Recall Bulletin

F/CMVSS NONCOMPLIANCE RECALL

SUBJECT: Passenger Side Instrument Panel Performance

MODELS: 2009-2014 Chevrolet Express
2009-2014 GMC Savana
1500 Series Equipped with Passenger Side Airbag (AK5)

3902849

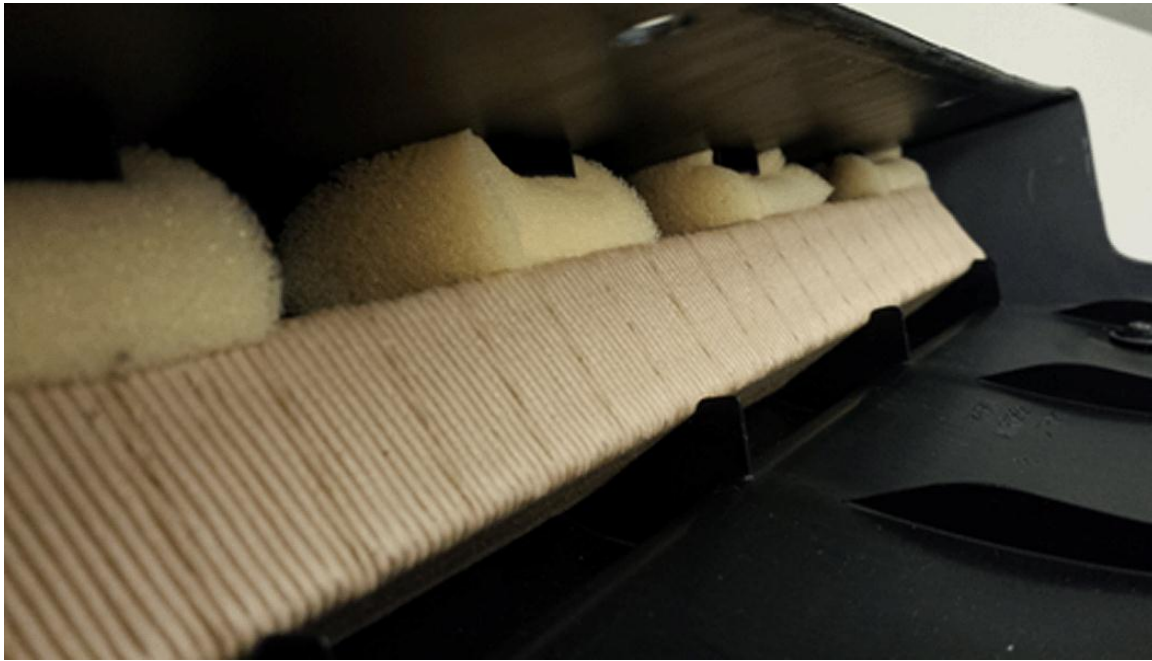
Step 3 of both service procedures have been revised. Please discard all copies of bulletin 14105A.

3. Inspect the brow assembly before installation to ensure the energy absorbing material and form are present. In the event that the energy absorbing material or foam has fallen out during shipment, follow the steps below to reinstall the components prior to installing the brow assembly on the vehicle.

- 3.1 Install the energy absorbing material into the brow so that the barcode is facing towards you and is resting on the four angled ribs.

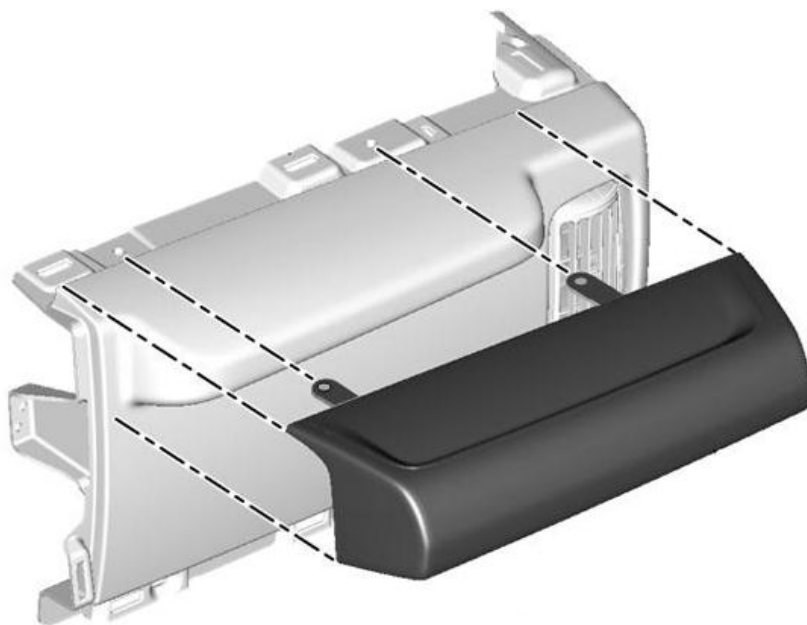
- 3.2 Using your fingers or a trim stick, install the four pieces of foam in between the energy absorbing material and the brow. Be sure the foam is on the opposite side of the energy absorbing material from the ribs structure. The foam should line up with the four features on the brow.
- 3.3 Turn the brow assembly over to ensure the components have been successfully installed and do not fall out.

3902849

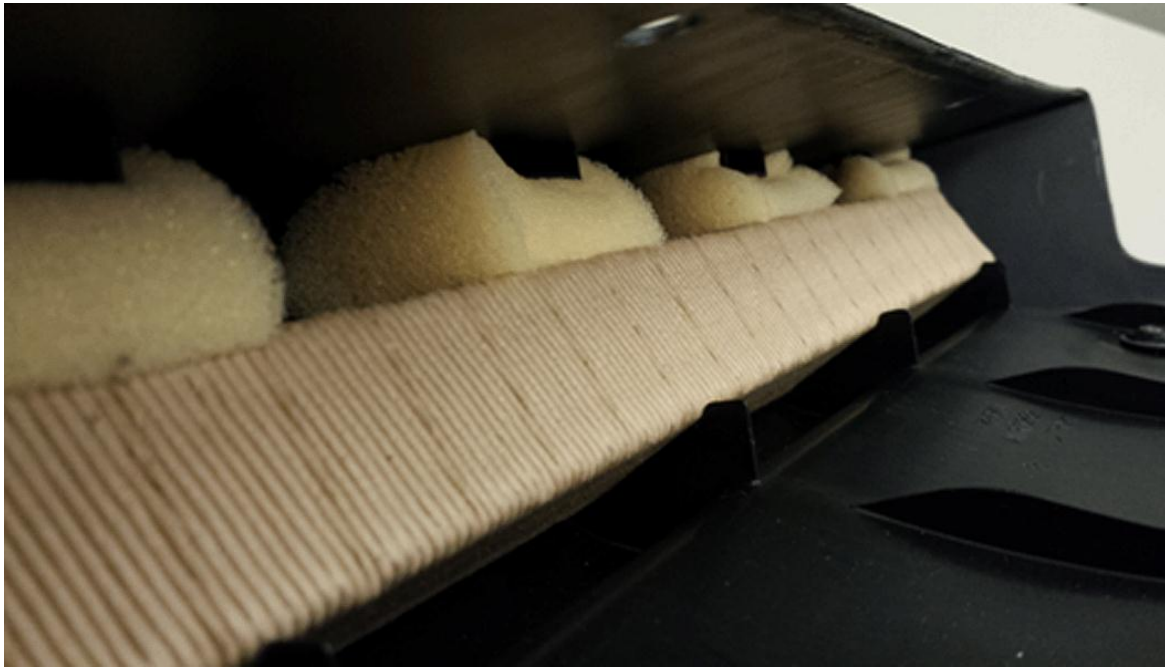
3. Inspect the brow assembly before installation to ensure the energy absorbing material and form are present. In the event that the energy absorbing material or foam has fallen out during shipment, follow the steps below to reinstall the components prior to installing the brow assembly on the vehicle.

3.1. Install the energy absorbing material into the brow so that the barcode is facing towards you and is resting on the four angled ribs.

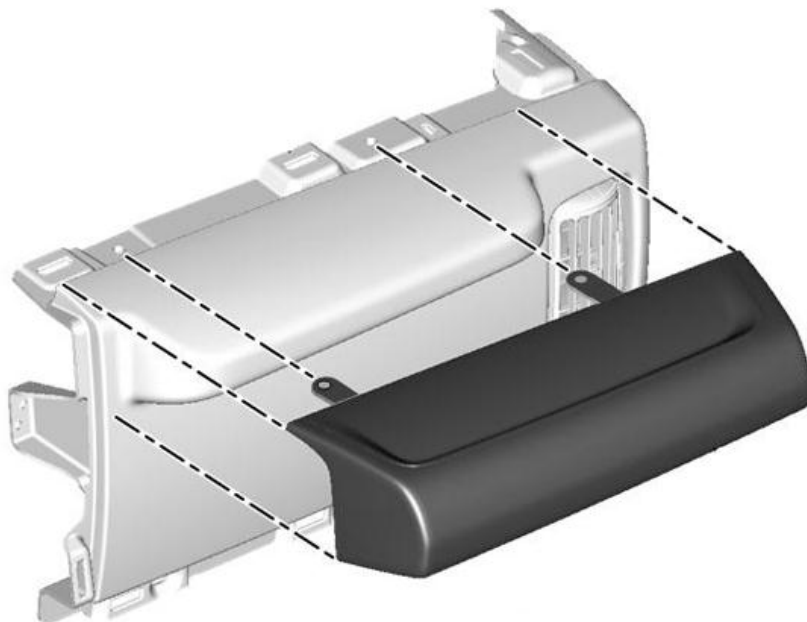
- 3.2. Using your fingers or a trim stick, install the four pieces of foam in between the energy absorbing material and the brow. Be sure the foam is on the opposite side of the energy absorbing material from the ribs structure. The foam should line up with the four features on the brow.
- 3.3. Turn the brow assembly over to ensure the components have been successfully installed and do not fall out.
